10/650,350

Jeffrey J. Norris

Office Action Summary

DETAILED ACTION

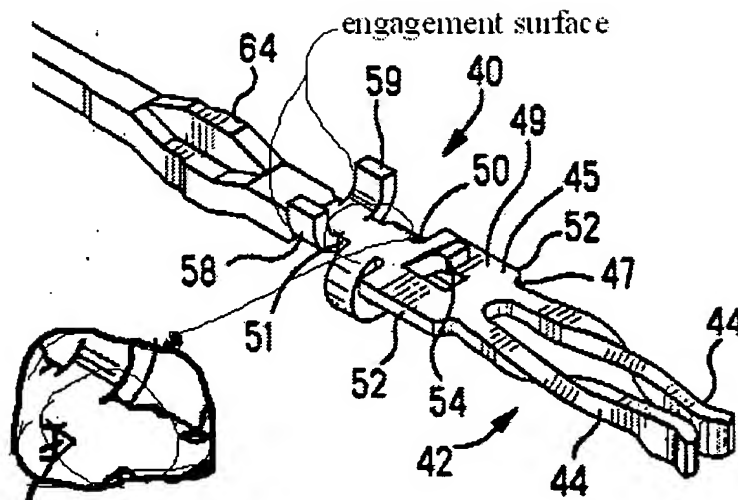
-- In reference to Claim(s) 8, Ruehleemann shows (figure 7)

- a) a first section (see examiner's figure) that receives an electrical contact;

b) a second section (see examiner's figure) that can be configured for insertion into a through hole of a circuit board, and with 1st and 2nd pin members (see examiner's figure),

c) a third section integral with the first and second section (see examiner's figure), the third section including:

- i) a contact surface oriented generally perpendicular to the longitudinal axis of the electrical terminal, the contact surface can be configured to receive a force applied to position the electrical contact within the through hole of the circuit board (see examiner's figure);
- ii) at least three engagement surfaces oriented opposite the contact surface (see examiner's figure),
the engagement surfaces can be configured to contact the circuit board to limit the depth of insertion of the electrical terminal within the through hole of the circuit board.

-- In reference to Claim(s) 11, Ruehlemann shows (see examiner's figure) a plurality of projections 224 extending from, and spaced apart from the third section of the electrical terminal (see examiner's figure).

shoulder construction further defining the push surface of each of the arms

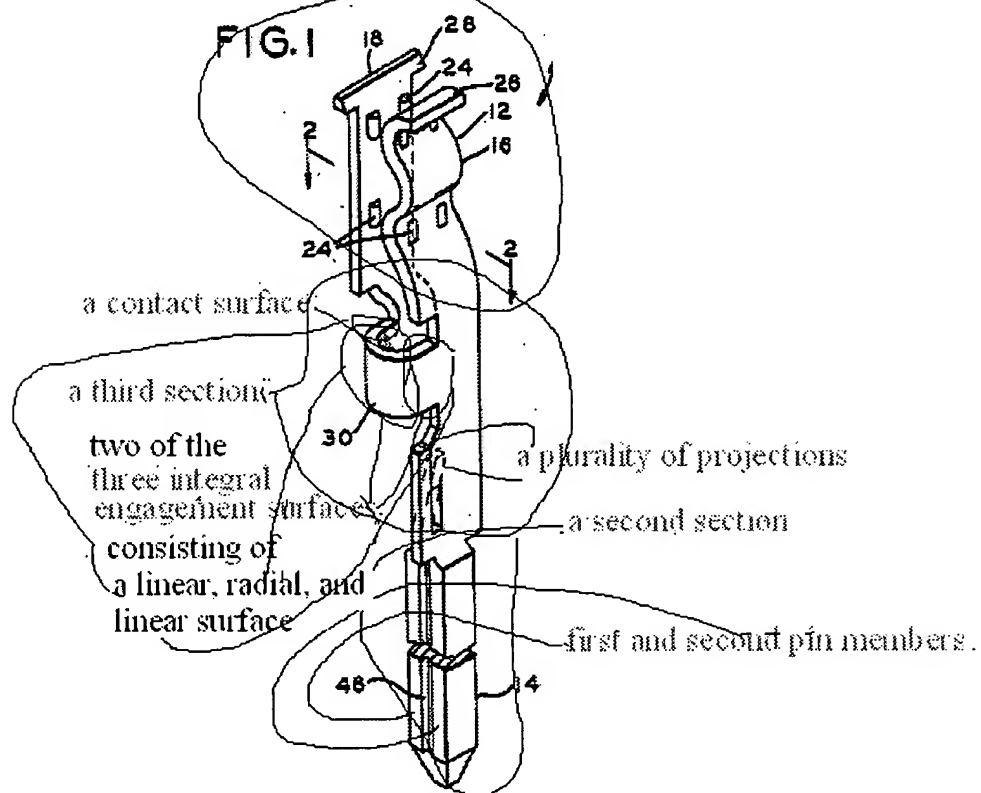
-- In reference to Claim(s) 3, Costello shows (cover sheet) the insertion structure 40 includes a shoulder (radius between arms and the longitudinal axis and element 47 on arms 52) construction interconnecting each of the arms, the shoulder construction further defining the push surface of each of the arms (see examiner's figure).

shoulder (the radius that the lead line of numeral 30 touches) construction interconnecting each of the arms, the shoulder construction further defining the push surface of each of the arms (see examiner's figure).

a first section that receives an electrical contact;

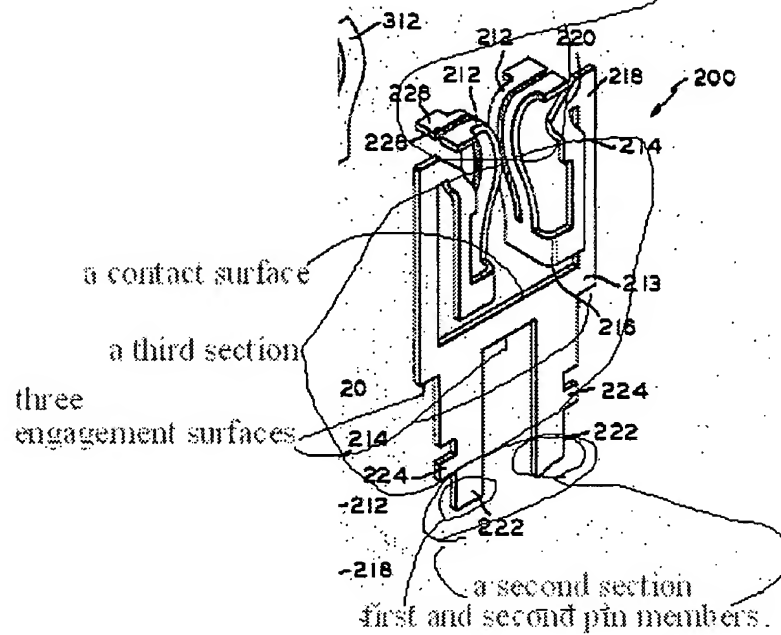
-- In reference to Claim(s) 8, Travis shows (figure 1)

- a) a first section (see examiner's figure) that receives an electrical contact;
- b) a second section (see examiner's figure) configured for insertion into a through hole of a circuit board, and 1st and 2nd pin members (see examiner's figure),
- c) a third section integral with the first and second section (see examiner's figure), the third section including:
 - i) a contact surface oriented generally perpendicular to the longitudinal axis of the electrical terminal, the contact surface can be configured to receive a force applied to position the electrical contact within the

- ii) at least three engagement surfaces oriented opposite the contact surface (see examiner's figure), the engagement surfaces can be configured to contact the circuit board to limit the depth of insertion of the electrical terminal within the through hole of the circuit board.

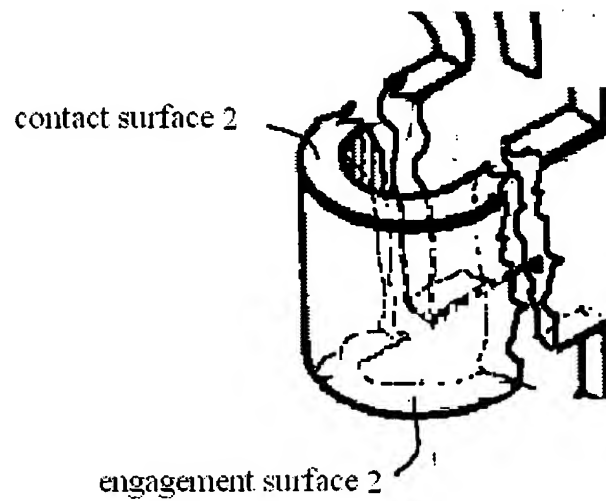
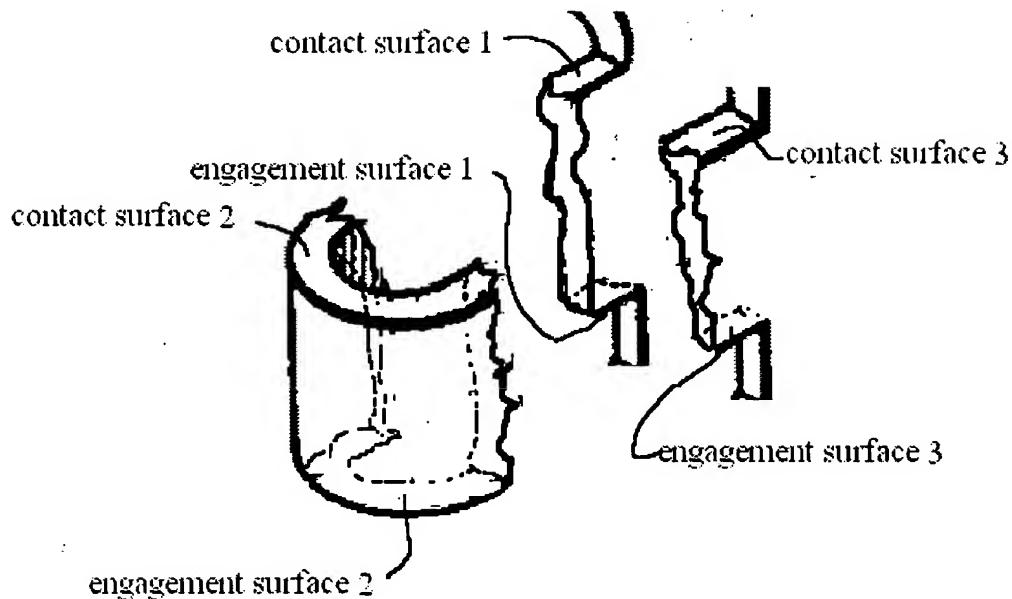
ends of the terminal body. The main body of the terminal is seen to be generally defined in the claims as containing three parts (e.g. first end, second end, and the insertion structure). This only requires that a continuous metal structure (e.g. insertion structure) to be between the first end and second end. Element 45 does depend upon the continuous metal structure because it projects from it and if the continuous metal structure was not present, the only other structure that is defined in the claim to mount Element 45 would either the first or second ends of which it is not mounted.

-- In response to applicant's argument (page 7, lines 15-20) concerning that element 30 was used to anticipate both the claimed insertion structure and the arms, the examiner disagrees. The rejection on page 5 of the office action indicates the insertion structure is near the element that is labeled with the numeral 30, not that the insertion structure is 30. The main body of the terminal is seen to be generally defined in the claims as containing three parts (e.g. first end, second end, and the insertion structure). This only requires that a continuous metal structure (e.g. insertion structure) to be between the first end and second end. Travis meets the claimed structure and makes claim 1 unpatentable.

-- In response to applicant's argument (page 8, line 1) concerning applicant's assertion that Travis does not disclose three engagement surfaces oriented opposite the contact surface the examiner disagrees. Travis shows the push contact surfaces on top in the same manner that applicant's are structurally positioned and Travis shows the engagement surfaces are in the same structural location as applicant has claimed. The following figure is provide to show that Travis does show the claimed structure. The first figure shows the first linear, the radial, and the second

linear components that contain the three surfaces and the second figure shows the three components separated so that there is space for the lead lines.
